**EXISTING FACILITIES
EVALUATION REPORT**

Project: Episcopal Church of the
Resurrection
Greenwood, South Carolina

Re: Electrical Systems Evaluation

A/E Project Number: 10-C1070

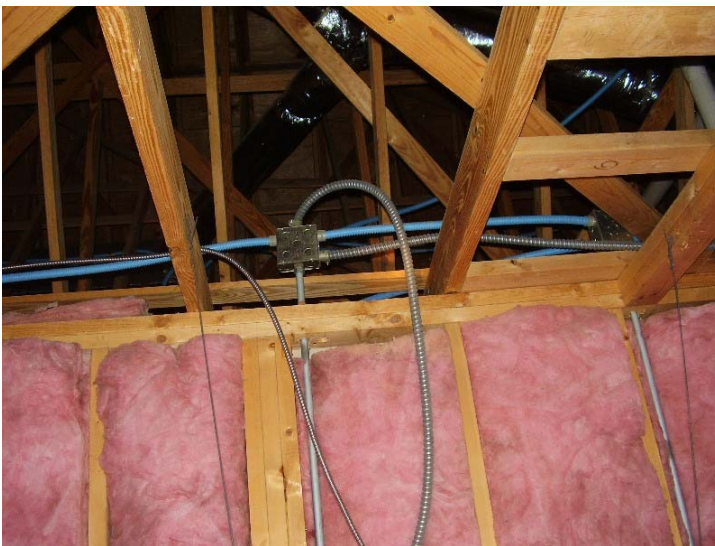
This photo is the top of a lay-in light fixture in Bishop's Hall showing the lack of hanger wires on the lights, as well as improper use and support of ENT conduit. By code, the ENT can run unsupported for a maximum of 6 ft at light fixture connections. Here it is being used in "daisy chain" fashion to wire from fixture to fixture.

4. Add emergency lights in the toilets.
5. Consider adding support wires to the lay-in fixtures. Because of the insulation batts on the ceiling, this work could best be accomplished as part of other work involving the ceiling.
